**SUSQUEHANNA STEAM ELECTRIC STATION
REQUEST FOR ADDITIONAL INFORMATION (RAI) FOR THE
REVIEW OF THE SUSQUEHANNA STEAM ELECTRIC STATION
UNITS 1 AND 2, LICENSE RENEWAL APPLICATION (LRA)
SECTIONS 2.2, 2.3.3, 2.3.4
PLA-6276**

**Docket Nos. 50-387
and 50-388**

Enclosure: PPL Responses to Request for Additional Information (Sections 2.2, 2.3.3, 2.3.4)

LR-M-120-1

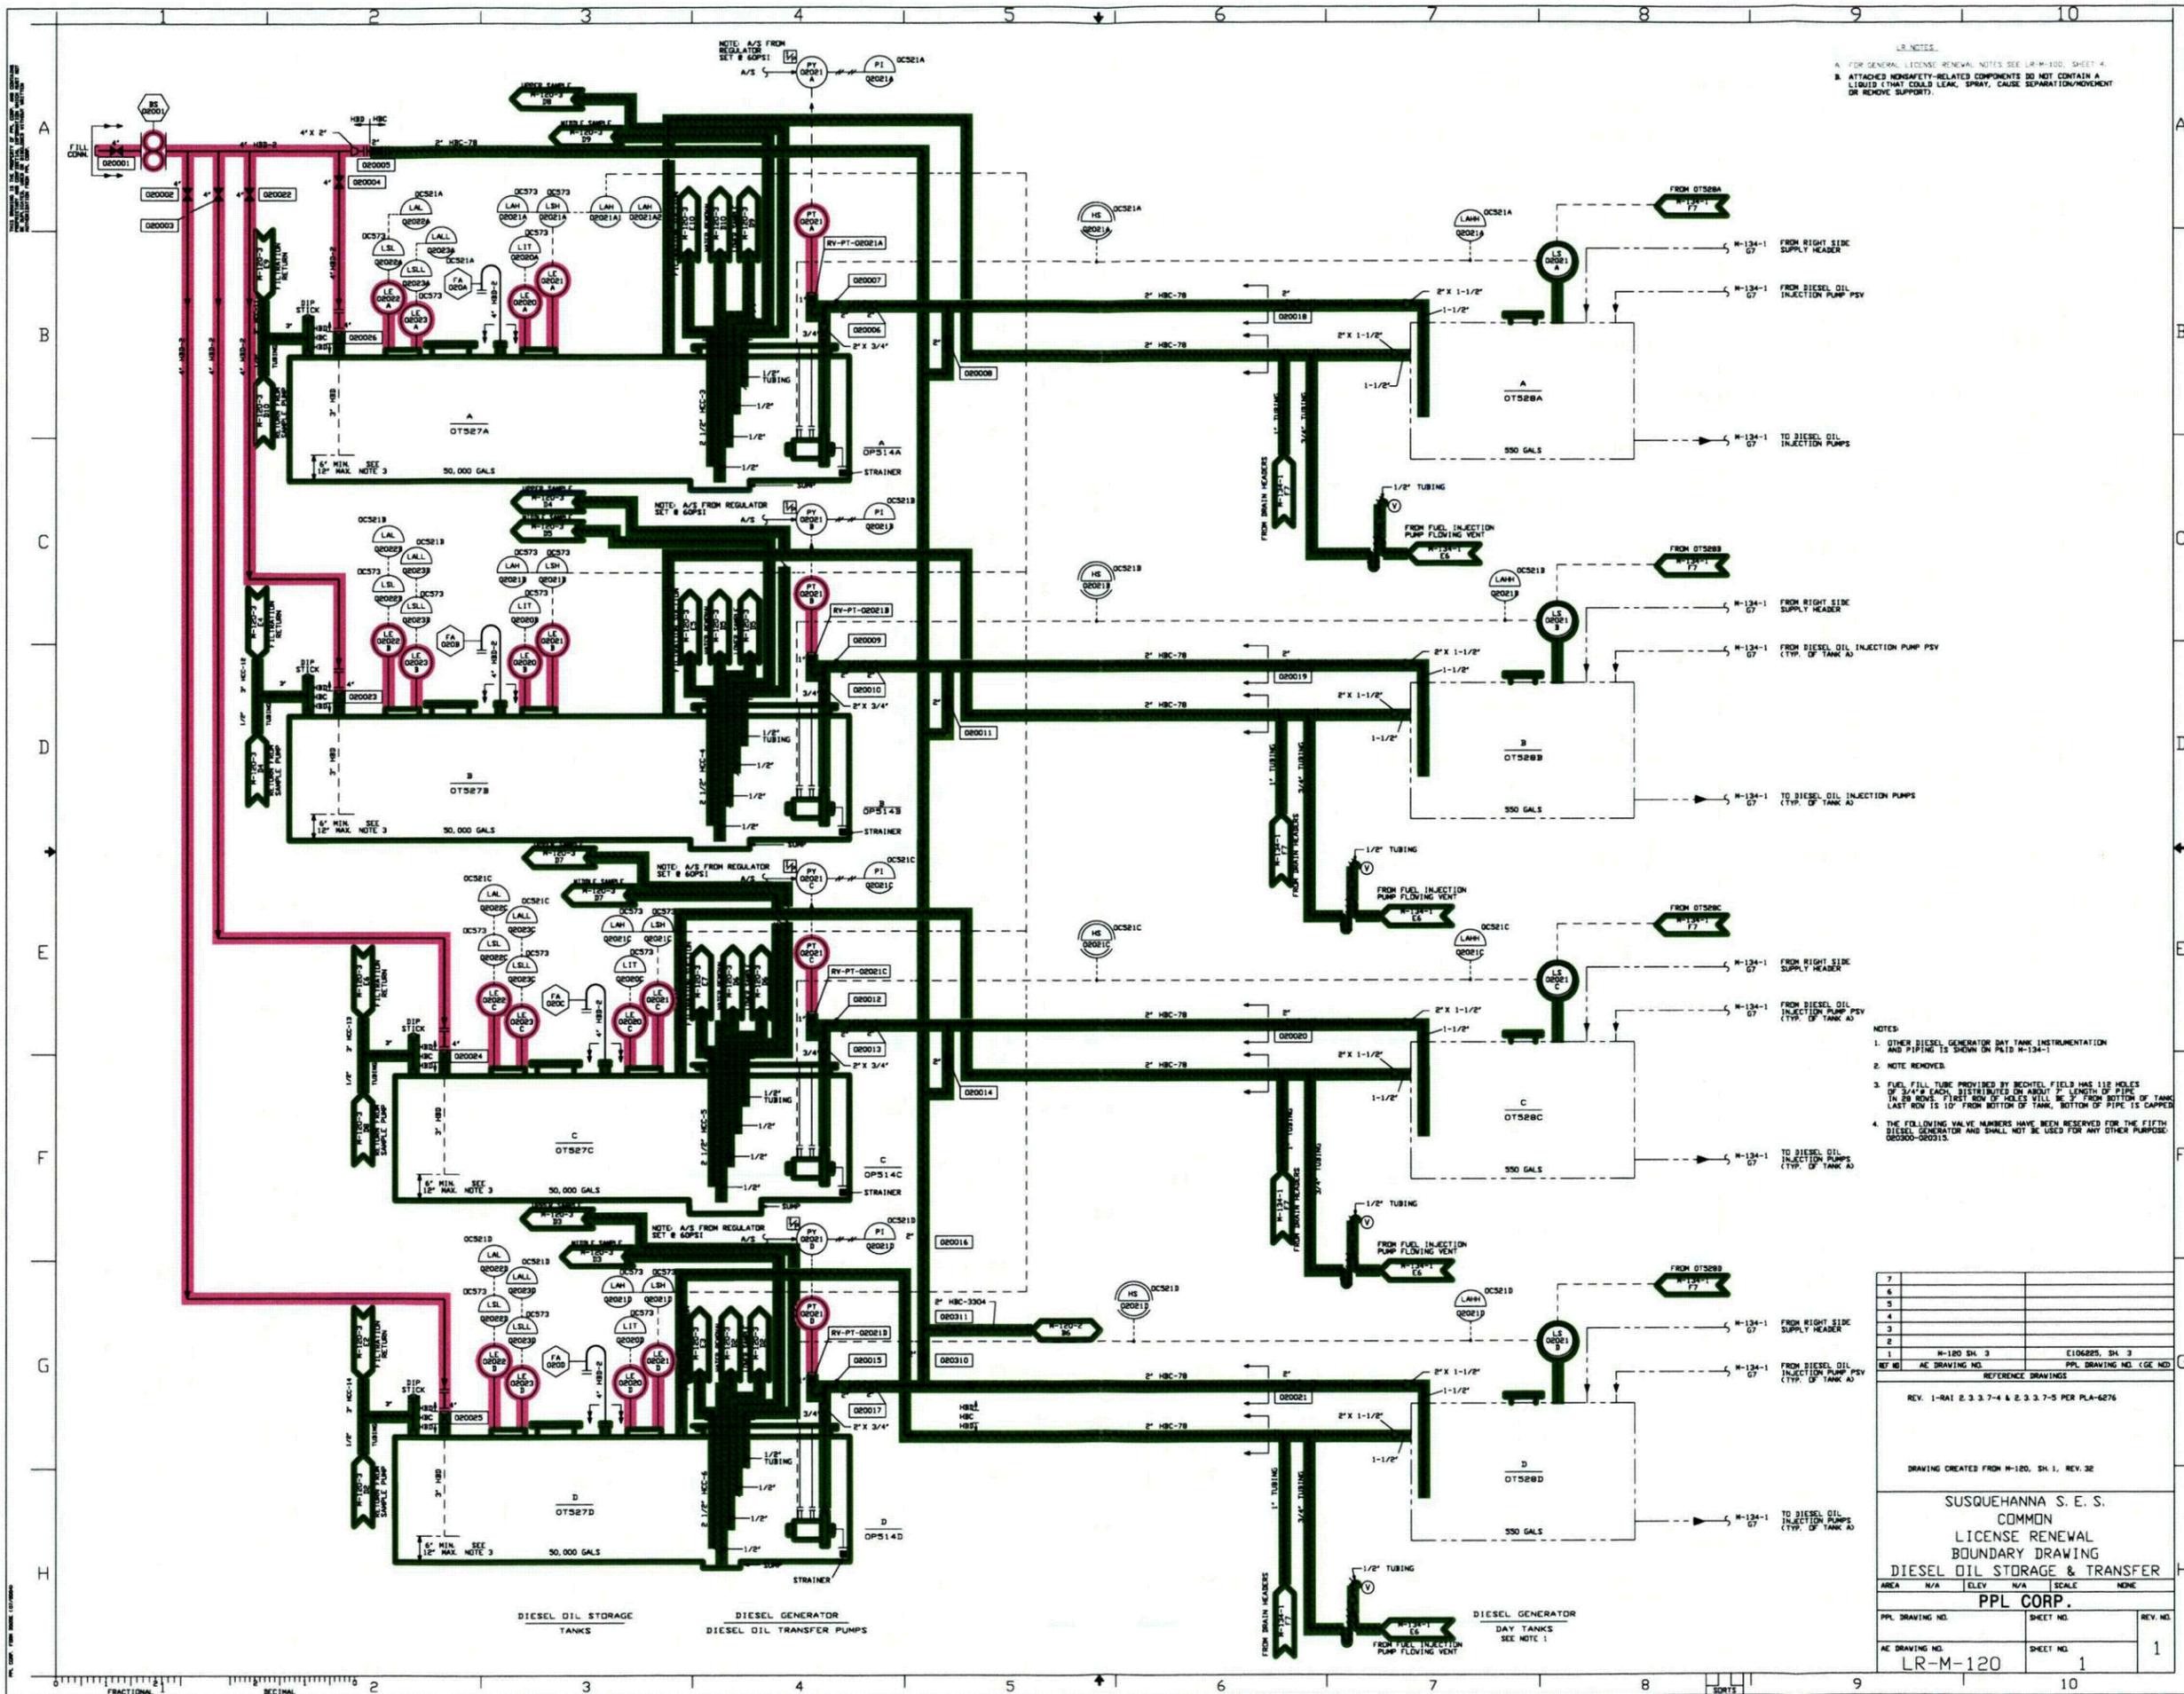
The diesel generator storage tank manhole covers shown in drawing LR-M-120-1, locations B2, D2, F3, and G3, are not shown within the scope of license renewal. Provide additional information explaining why the manhole covers are not shown within the license renewal scope boundary.

License renewal drawing LR-M-120-1, locations B7, D7, E7, and G7, indicate that there are manhole covers on top of the diesel generator day tanks A, B, C, and D. However, drawing LR-M-134-1, location F8, does not show a manhole cover on the top of diesel generator day tanks A, B, C, and D. Provide additional information to explain whether or not there actually are manhole covers on the four tanks. If there are manhole covers on these tanks, provide additional information explaining why they are not shown on drawing LR-M-134-1 and why they are not within the scope of license renewal.

The diesel generator storage tank manholes and covers shown on drawing LR-M-120-1 are within the scope of license renewal. A highlighting error resulted in the manholes and covers on drawing LR-M-120-1 not being indicated as within the scope of license renewal.

DRAWING	CONDITION	CHANGE
LR-M-120-1	The manholes and covers for tanks 0T527A, B, C, and D are not highlighted. The manholes and covers are required as part of the pressure boundary of the tanks and are within the scope of license renewal.	Highlight (in green) the manholes and covers for tanks 0T527A, B, C, and D.

It was determined that the diesel generator day tank manholes and covers shown on drawing LR-M-120-1 should be shown as within the scope of license renewal. The manholes and covers are part of the pressure boundary of the storage tanks.

DRAWING	CONDITION	CHANGE
LR-M-120-1	The manholes and covers for tanks 0T528A, B, C, and D are not highlighted. The manholes and covers are required as part of the pressure boundary of the tanks.	Highlight (in green) the manholes and covers for tanks 0T528A, B, C, and D to indicate the components are within the scope of license renewal.

LR-M-134-1

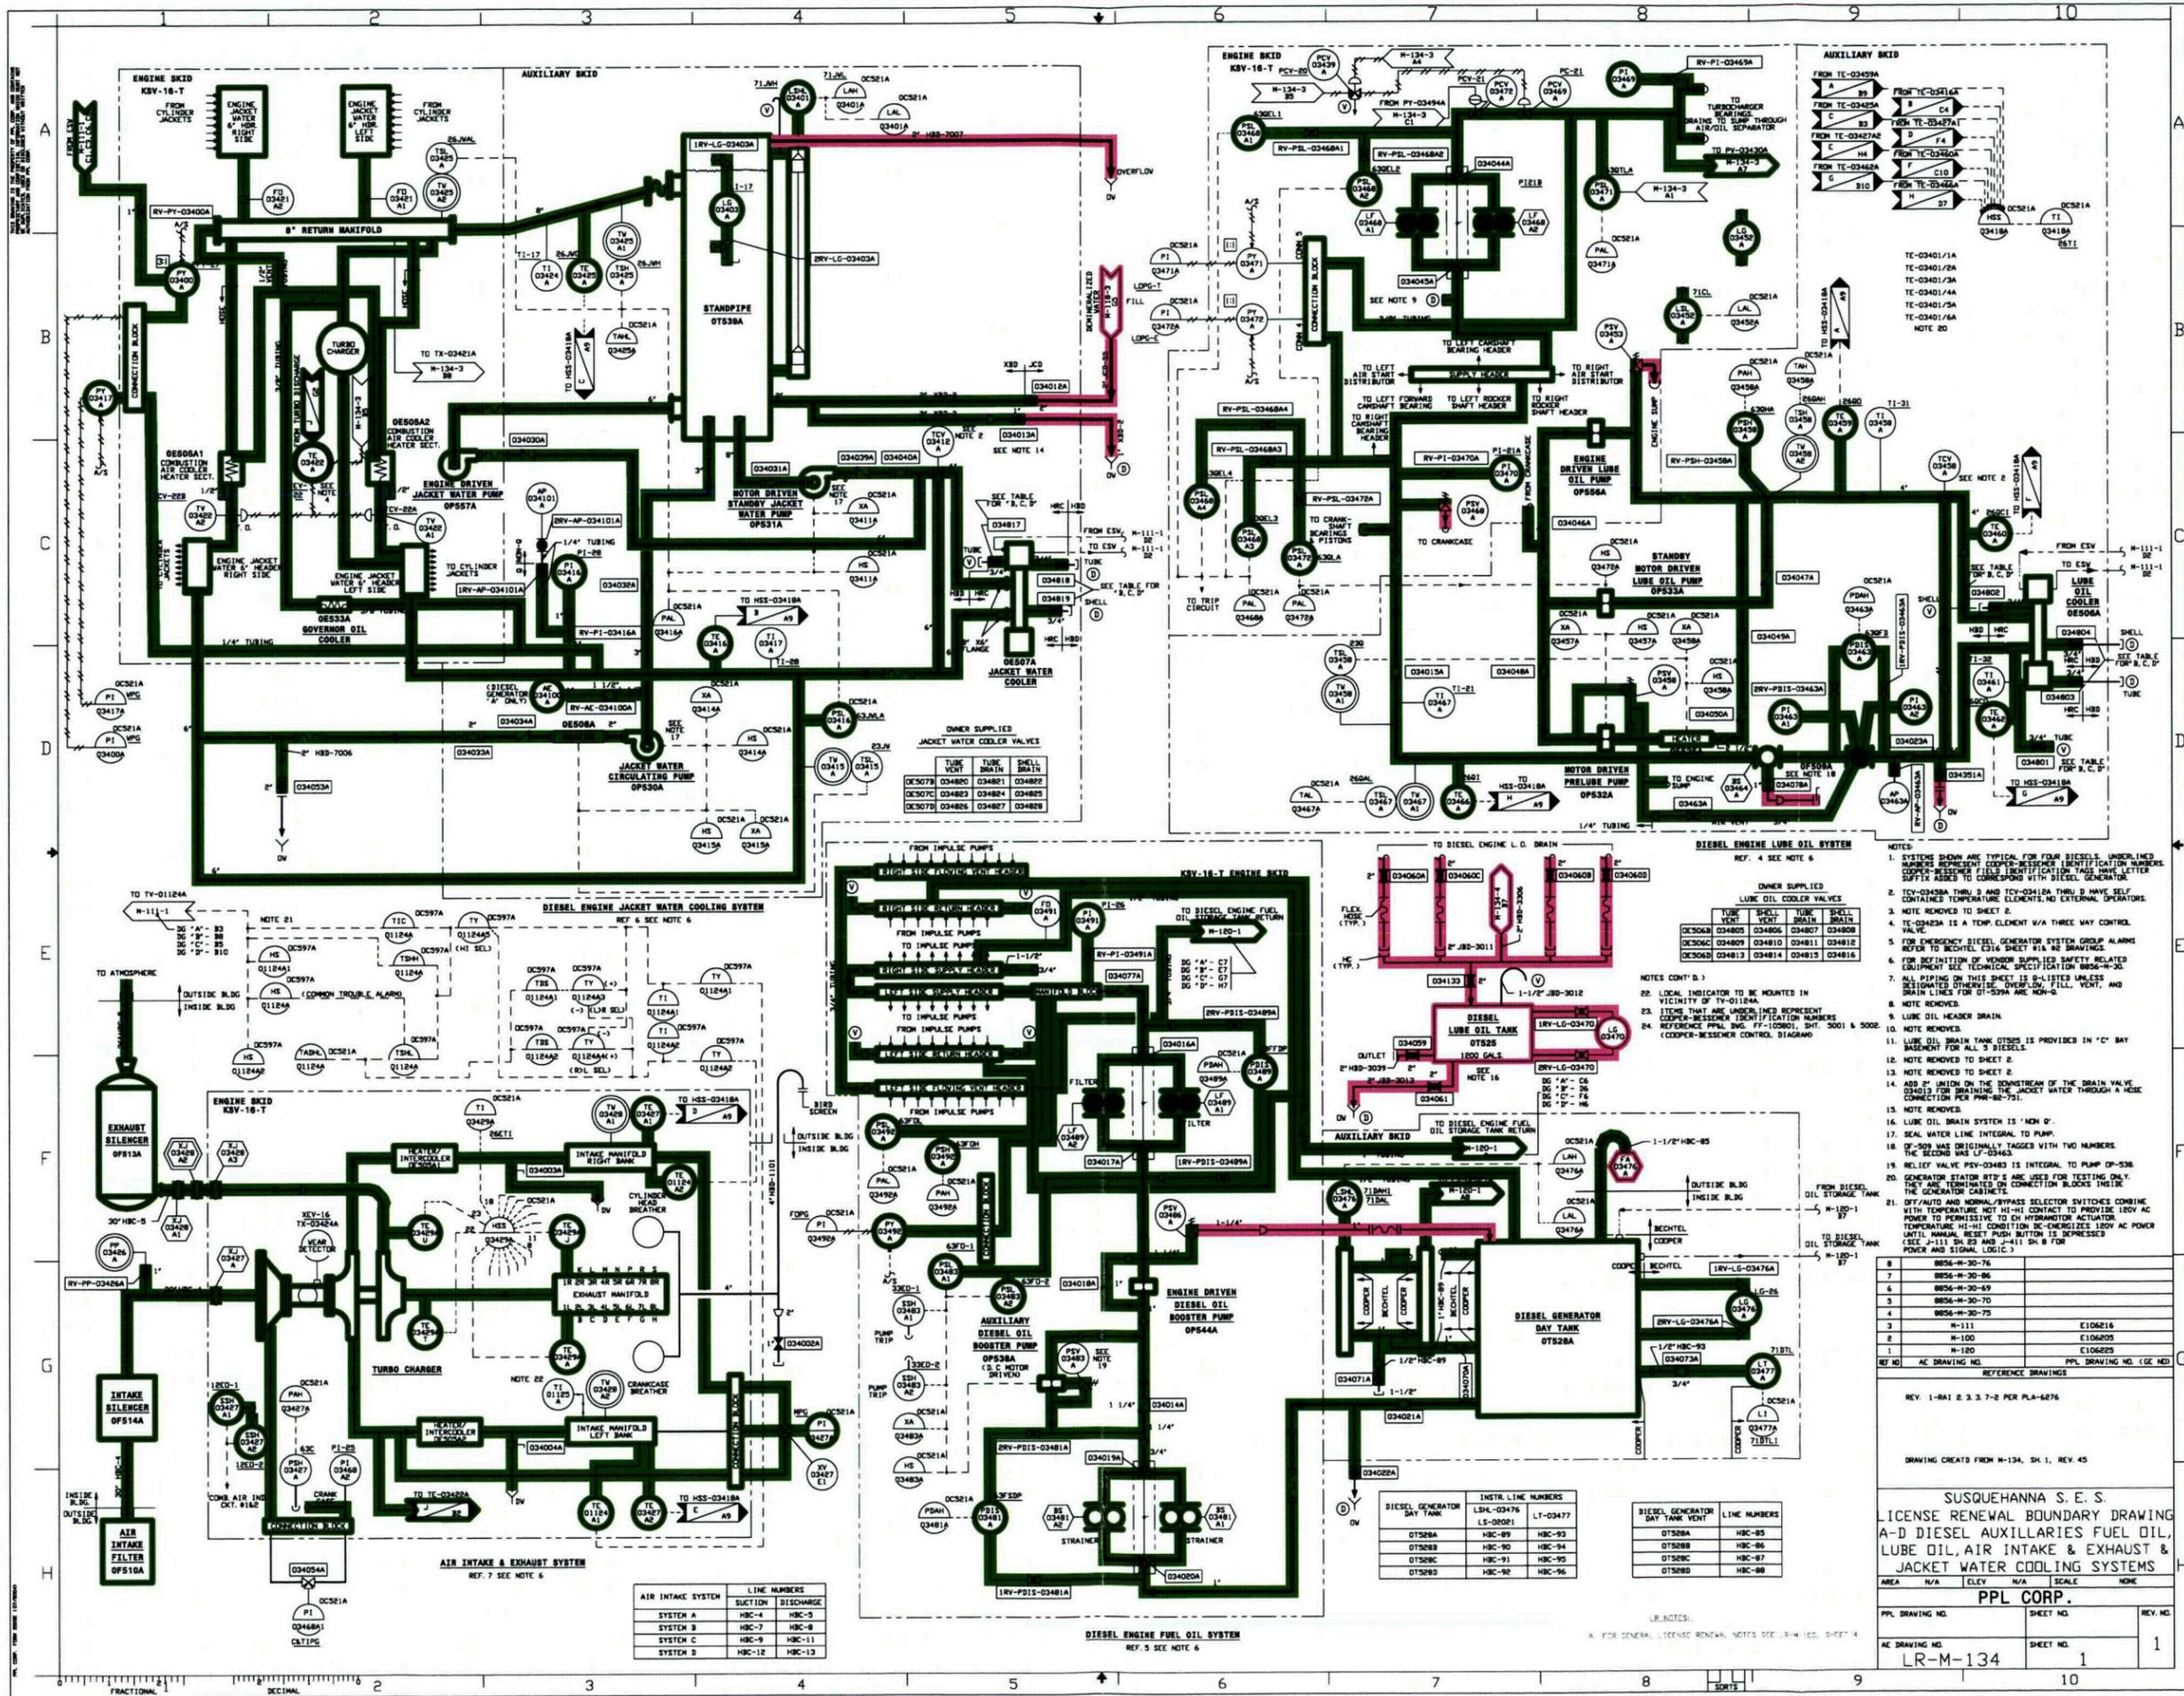
The diesel generator day tank flame arrestors shown on license renewal drawing LR-M-134-1, location F8, and drawing LR-M-134-7, location A8, are within the scope of license renewal, but are not included in LRA Table 2.3.3-7 for components subject to an AMR. The flame arrestor is typically included in the table because it is classified as a component subject to an AMR within the diesel fuel oil tanks. The flame arrestors are shown within the scope of license renewal for different reasons on the two drawings. Provide additional information explaining why the flame arrestors are shown within scope, but not included in Table 2.3.3-7, and why the flame arrestors are shown within scope for different reasons.

The flame arrestors on the A-D diesel day tank vent lines on drawing LR-M-134-1 are not classified as safety-related. Drawing LR-M-134-1 has been revised to include the flame arrestors within the scope of license renewal per the criteria of 10 CFR 54.4(a)(2).

DRAWING	CONDITION	CHANGE
LR-M-134-1	The flame arrester (FA03476A) for tank 0T528A is not highlighted. The flame arrester is attached to safety-related piping and is within the scope of license renewal per 10 CFR 54.4(a)(2).	Highlight (in pink-magenta) the flame arrester (FA03476A) at drawing location F8.
LR-M-134-7	The vent piping from the diesel generator day tank is highlighted pink (magenta) up to the point at which it exits the Diesel Generator E building into the yard. The piping in the yard up to and including the flame arrester should also be within the scope of license renewal per 10 CFR 54.4(a)(2).	Highlight (in pink-magenta) the piping and flame arrester (FA03476E) at drawing location A8 which continues into the yard from the Diesel Generator E building and is connected to in scope (pink-magenta) piping.
